AERONAUTICAL CHARTING FORUM
Instrument Procedures Group
October 27, 2009
HISTORY RECORD

FAA Control # 09-02-288

Subject: LNAV/VNAV Minimums vs. Circle to Land Minimums

RNAV (GPS) RWY 13

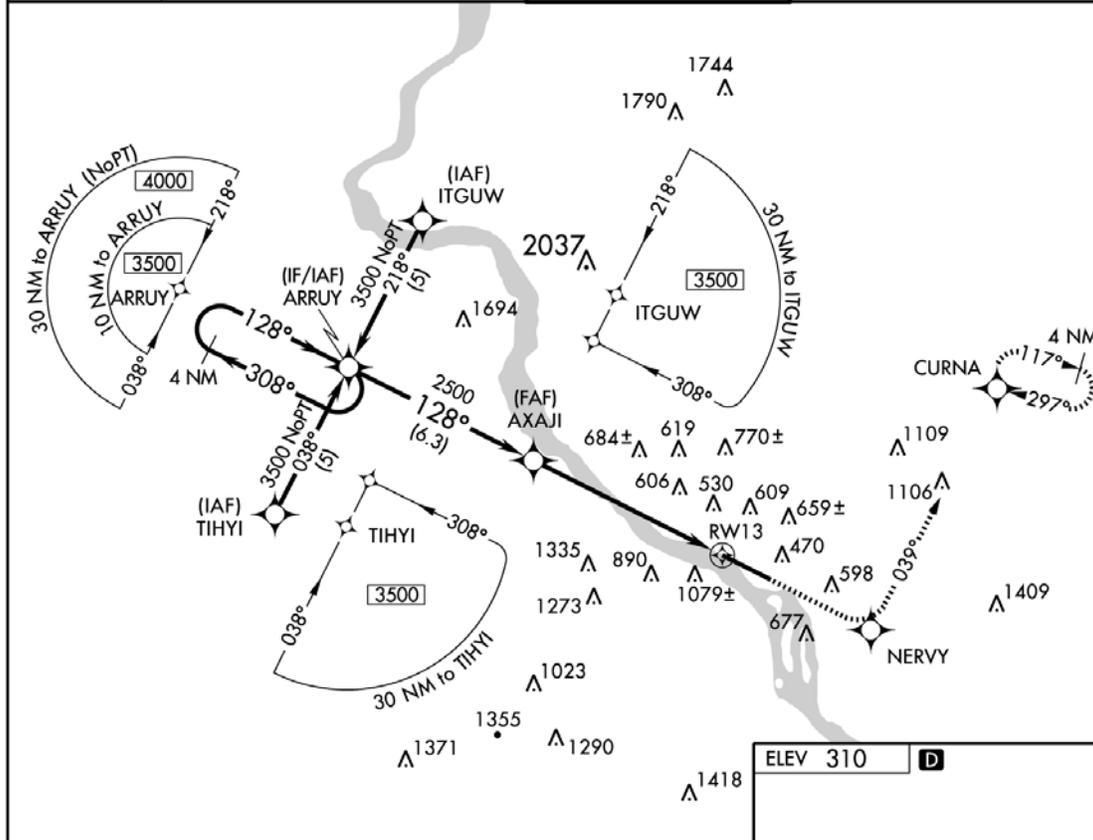
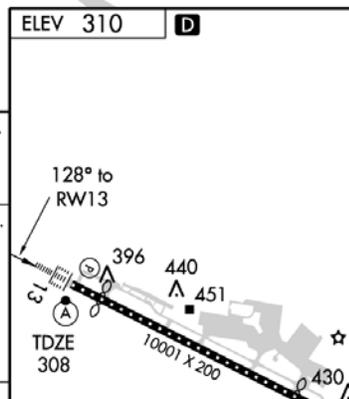
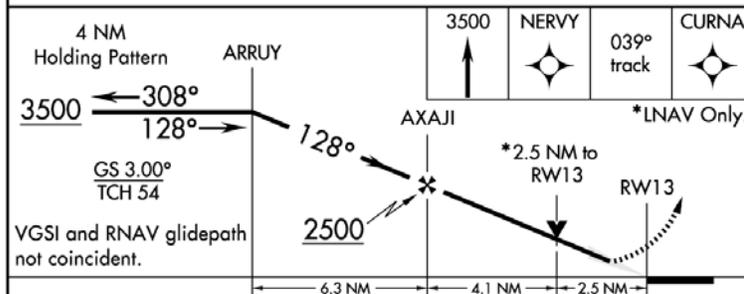
However, lower circle-to-land minimums are currently published on some RNAV IAPs that combine LPV, LNAV/VNAV, and LNAV procedures provided the circle-to-land minimums are not lower than the LNAV NPA minimums. (See the attached KMDT RNAV 13, where the CMDA is 392 feet lower than the LNAV/VNAV DA). Pilots equipped for LNAV/VNAV, but not for LPV, are rightfully confused about how to fly to circle-to-land minimums on a SIAP like the KMDT RNAV 13. This is an undesirable and unnecessary procedural complication.

Recommendations: Whenever the LNAV/VNAV DA is higher than the LNAV MDA, publish the LNAV/VNAV procedure as a separate SIAP, with circling minimums not less than the straight-in minimums. (In the example SIAP's case, the CMDA on the LNAV/VNAV IAP would be 1,580 and on the LPV and LNAV IAPs 1,180.)
